ADDENDUM NO. 2

Date: March 23, 2021
Project Name: SH-37 Sanitary Sewer Relocation at Little River Bridge
Owner: City of Moore
Garver Project No. 21W02390

STATE JOB NO. J/P 31257 SHEET NO. 4

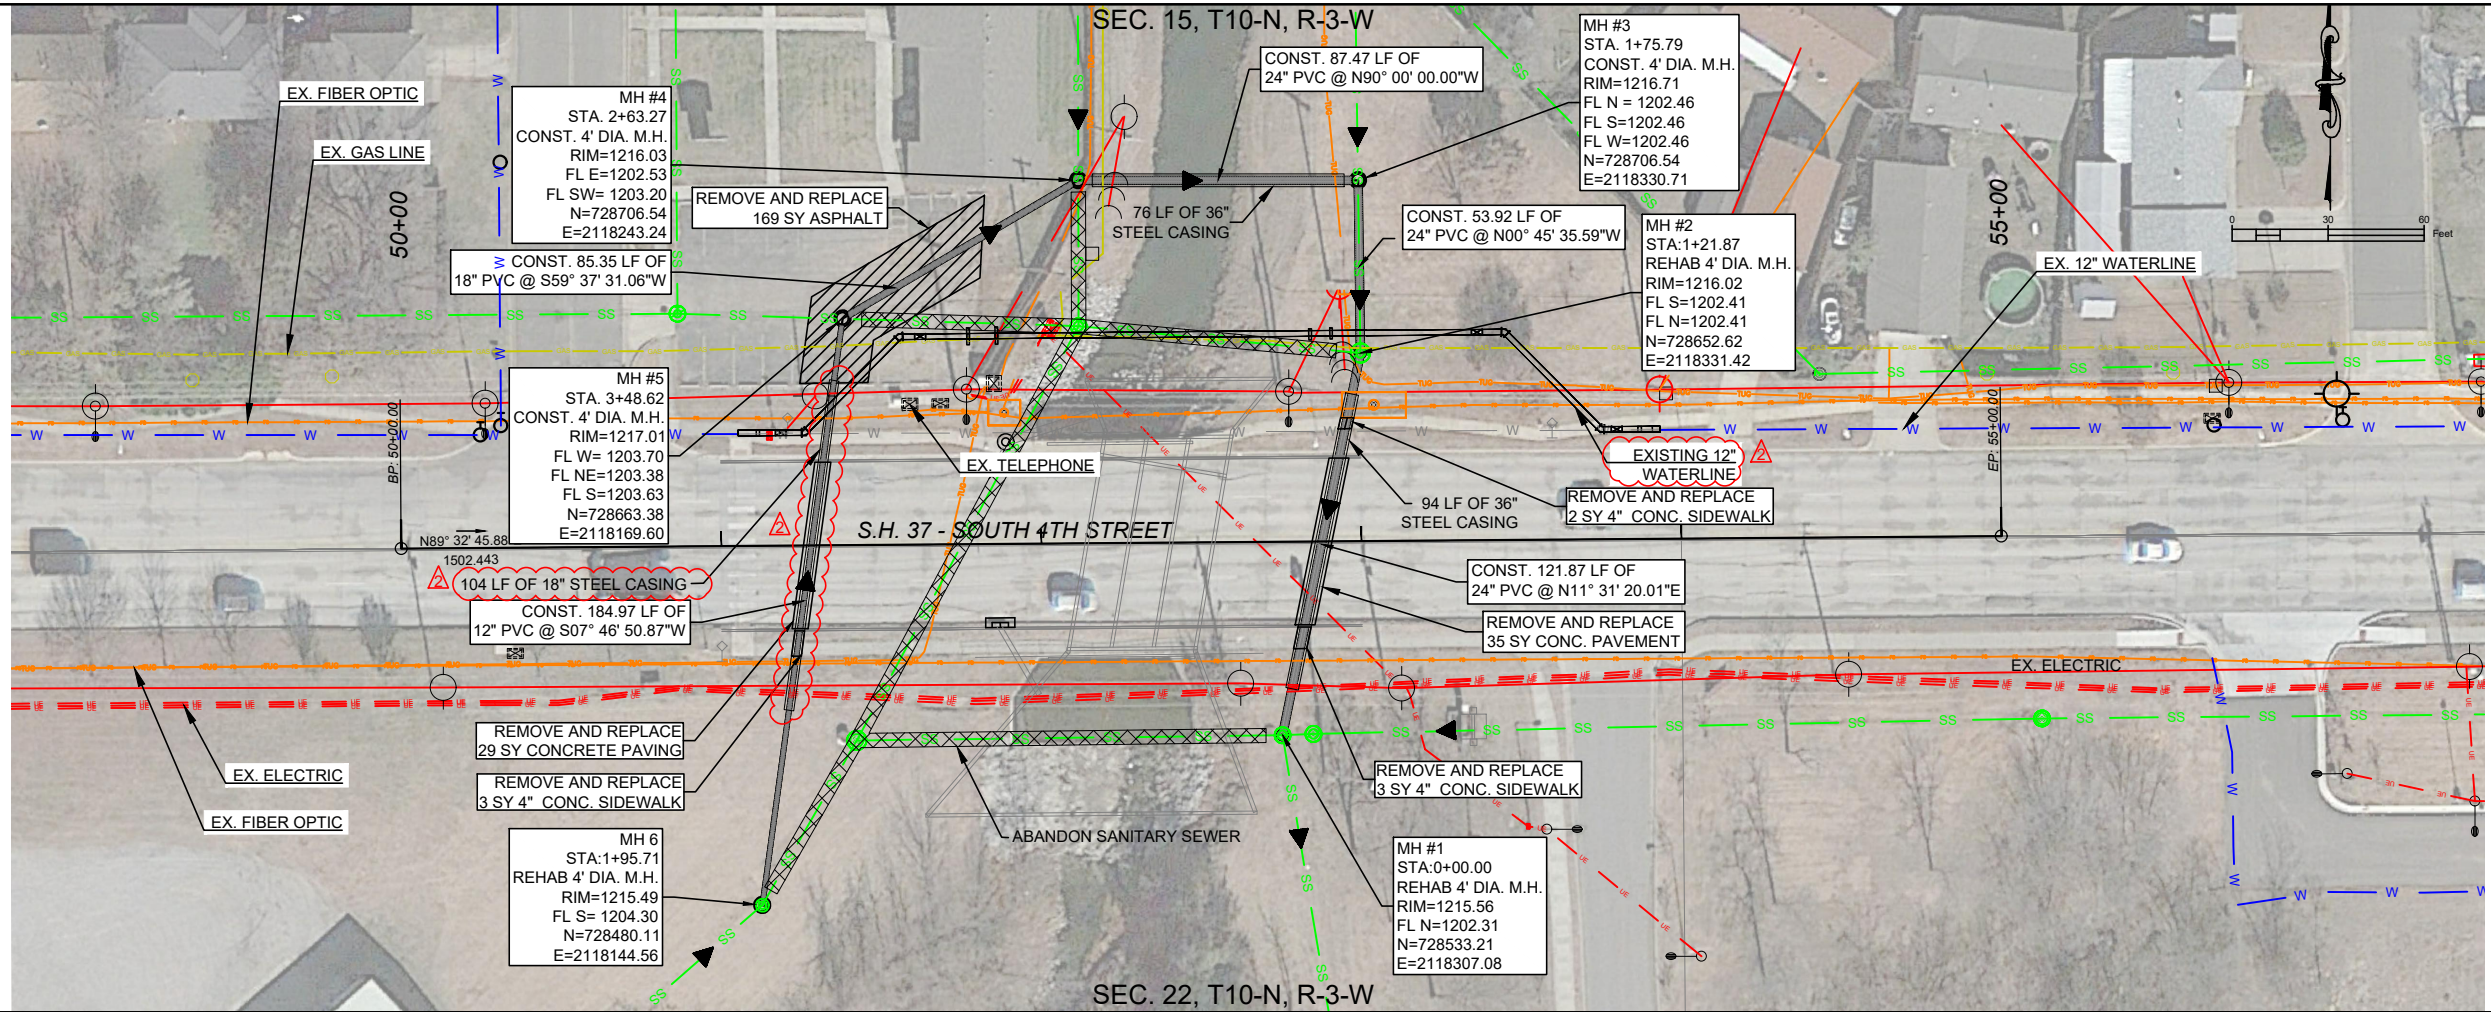
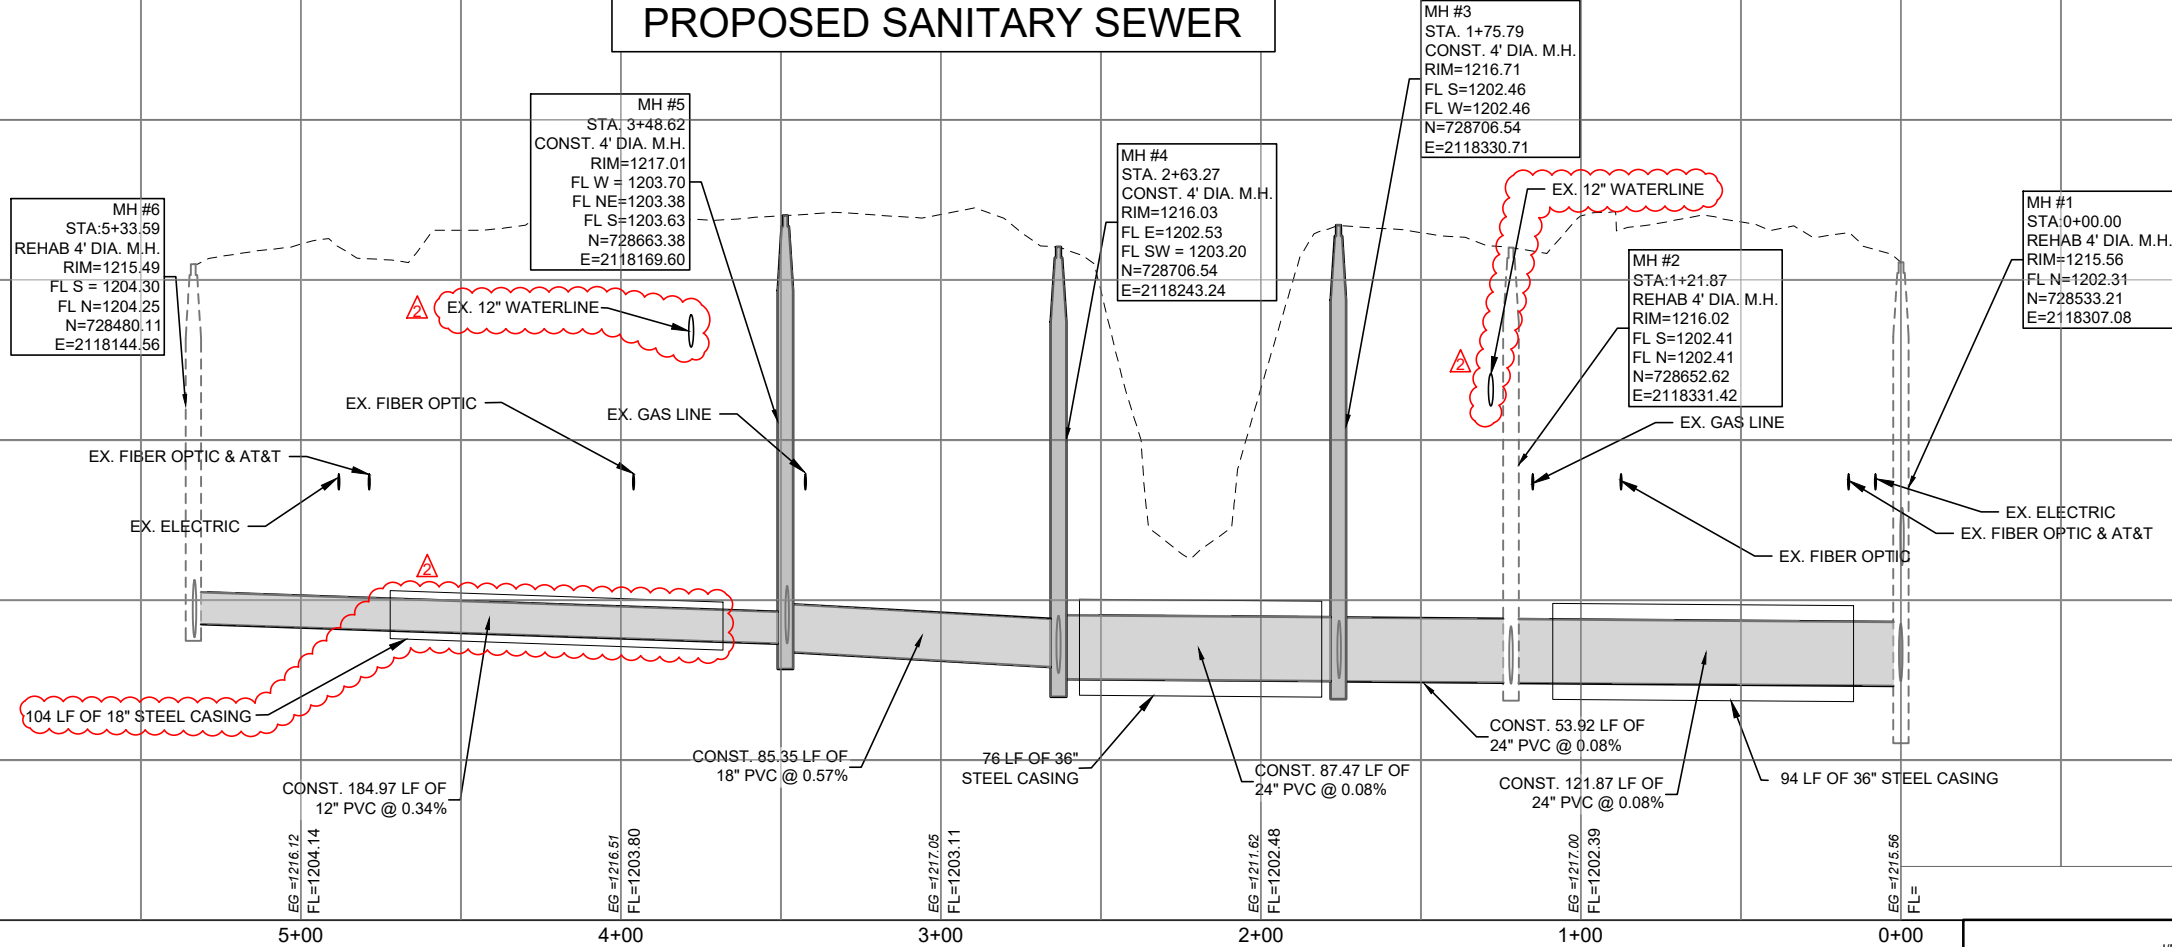
2. Revise Sheet 4 – PLAN AND PROFILE

- a. Increased length of steel casing between MH #5 and MH #6 to 104 L.F.
- b. Revised callout for 12" Water Line from Proposed to Revised (see Clarifications below).

- 1. The "Proposed Water Line" indicated on the plans is already installed as shown on Sheet 4, which is why the callout for this line was revised to say "Existing Water Line."
- 2. "Can we bore across SH-37 instead of open cutting?"
 - a. Boring may be considered in lieu of open cutting at the Contractor's option provided it is not a cost increase.
